269D™ HELICOPTER

ASB DB-068

SUBJECT: ENGINE CONTROL SYSTEM – Adjustment of Power Controls – Revise N₂ Restrictions for Rolls-Royce® Turbine Engine Operation and Installation of Engine N₂ Avoidance Placard

ENGINE, TURBINE ASSEMBLY - STEADY-STATE OPERATION AVOIDANCE RANGE LIMIT

ENGINE N₂ AVOIDANCE PLACARD (269D0302-209) - FABRICATION
FIGURE 1

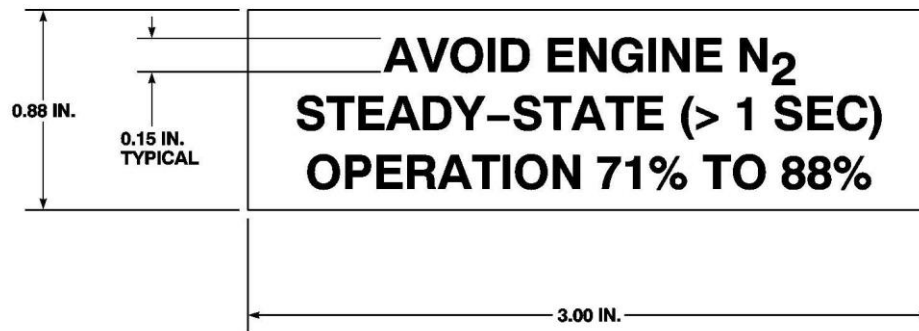
- C. If necessary, fabricate engine N₂ avoidance placard (269D0302-209 or 269D0302-211), depending on space on instrument panel, as follows (Refer to Figures 1 or 2):

NOTE: Text height shall be 0.15 inch (typical). All text shall be gothic bold font, and color shall be white on black background.

- (1) Using 3M™ Scotchcal™ graphic film (3650-12 or equivalent), fabricate engine N₂ avoidance placard (269D0302-209 or 269D0302-211) using dimensions shown in either Figure 1 or Figure 2.

250-C20 Maximum Allowable Output Shaft Speeds (P/N 23065818 and P/N 23055944)
FIG. 1

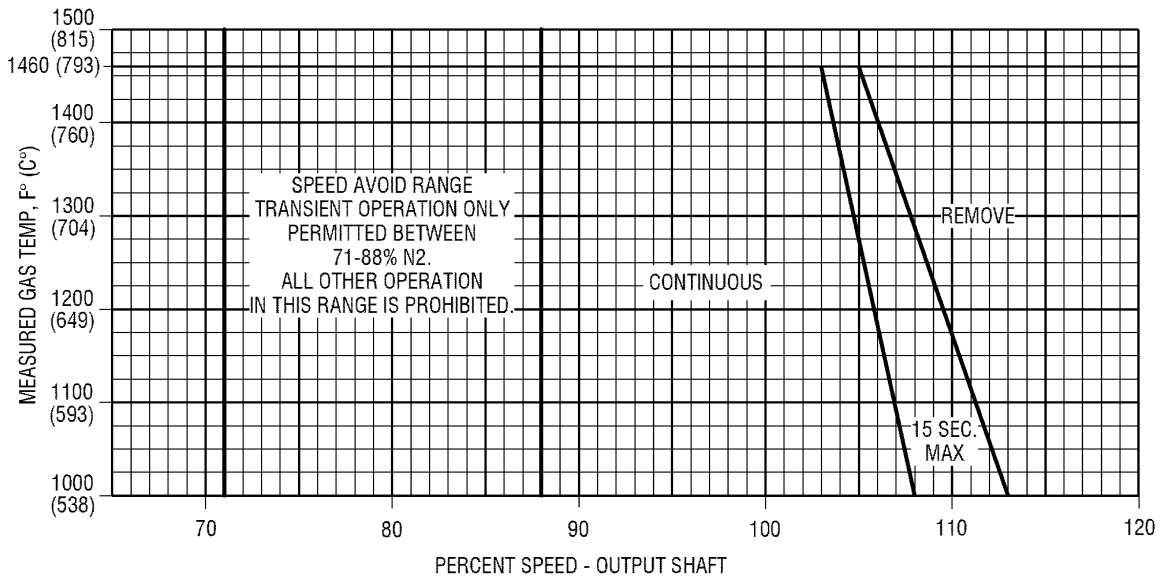
This CEB is being revised to communicate the new speed avoidance range for the 4th-stage Turbine Wheel P/N 23055944 installed in Turboshaft engines, and to incorporate the new 4th-stage Turbine Wheel P/N M250-10445. The required engine N2 speed avoidance range is dependent upon the part number of the Power Turbine Wheel in service, engine model, and the OEM application in which the engine is installed. Part numbers of the 3rd-stage and 4th-stage Turbine Wheels in service, engine models, and the OEM applications affected are as follows:

Speed Limit Tables for the enhanced P/N 23065818 3rd-stage Turbine Wheel and P/N 23055944 4th-stage Turbine Wheel have been updated to reflect the new speed avoidance range for wheels installed in Turboshaft engines, and to incorporate the new 4th-stage Turbine Wheel P/N M250-10445.

A mandatory 71% to 88% engine N2 steady-state speed avoidance range is required for all operational practices. Rolls-Royce must be consulted for additional guidance on the speed avoidance range for any OEM application that has a potential steady-state operating speed below 89% N2. Transient operation only is permitted in the speed avoidance range 71-88% N2. All other operation in the band is prohibited, in particular continuous operations (any dwell of more than one second) must be avoided. This action applies to all flight and ground maintenance (including track and balance) operational practices. (Ref. FIG. 1 and 2) Operation within the speed avoidance range is permitted for preflight checks specified in OEM flight manuals. In autorotation, with N2 split from NR and throttle in the Ground Idle position, unrestricted operation within the speed avoidance range is permitted. Transient operation in the speed avoidance range during recovery from autorotation is permitted.
